Butte Priority Soils Operable Unit (BPSOU) Revised Draft Final Insufficiently Reclaimed Sites Field Sampling Plan (FSP) BRES No. 181 – Mountain Con-3 Dump and Responses to Agency Comments

RE: Butte Priority Soils Operable Unit (BPSOU) Revised Draft Final Insufficiently Reclaimed Sites Field Sampling Plan (FSP) BRES No. 181 – Mountain Con-3 Dump and Responses to Agency Comments

Re: Butte Priority Soils Operable Unit (BPSOU) Revised Draft Final Insufficiently Reclaimed Sites Field Sampling Plan (FSP) BRES No. 181 – Mountain Con-3 Dump.

Figure 1 -Insufficiently Reclaimed Sites BRES No. 181 – Mountain Con-3 Dump Proposed Sample Stations

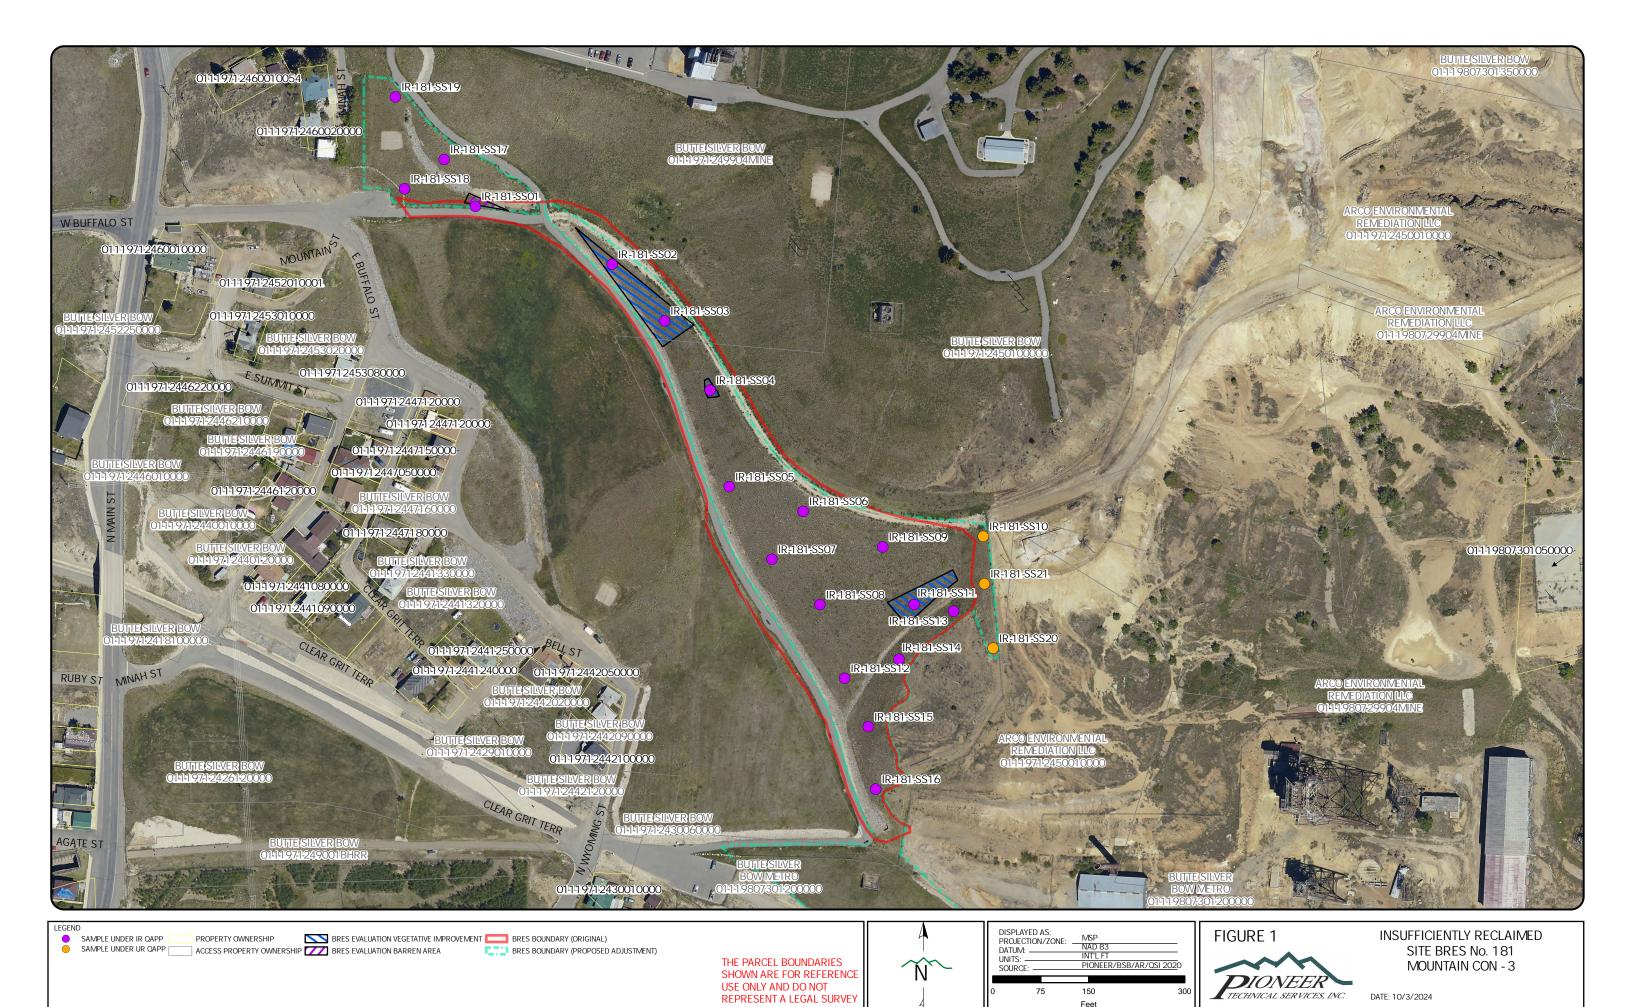
3. **Agency comment:** Section 2.0, Previous Findings. In the last paragraph, please add references for the 2017 and 2021 BRES evaluation summary reports. Later in the paragraph, it is stated that "barren areas are present throughout the site" although only one barren area is depicted on Figure 1. Please review the BRES site evaluations and consider if additional barren areas need to be shown on Figure 1.

4. **Agency comment:** Figure 1. EPA anticipates that it will approve the boundary adjustment for the Mountain Con-3 Dump (BRES No. 181) to the Mountain Con Mine Dump South (BRES No. 348). Please add samples to the extended area to the east and the south shown on Figure 1 and revise that sample numbers within the FSP accordingly.

Atlantic Richfield Response: The barren area shown on Figure 1 is consistent with Geographic Information System (GIS) data provided by Butte-Silver Bow (BSB). The text was revised to reflect Figure 1.

Atlantic Richfield Response: The FSP has been revised to include additional samples as requested.
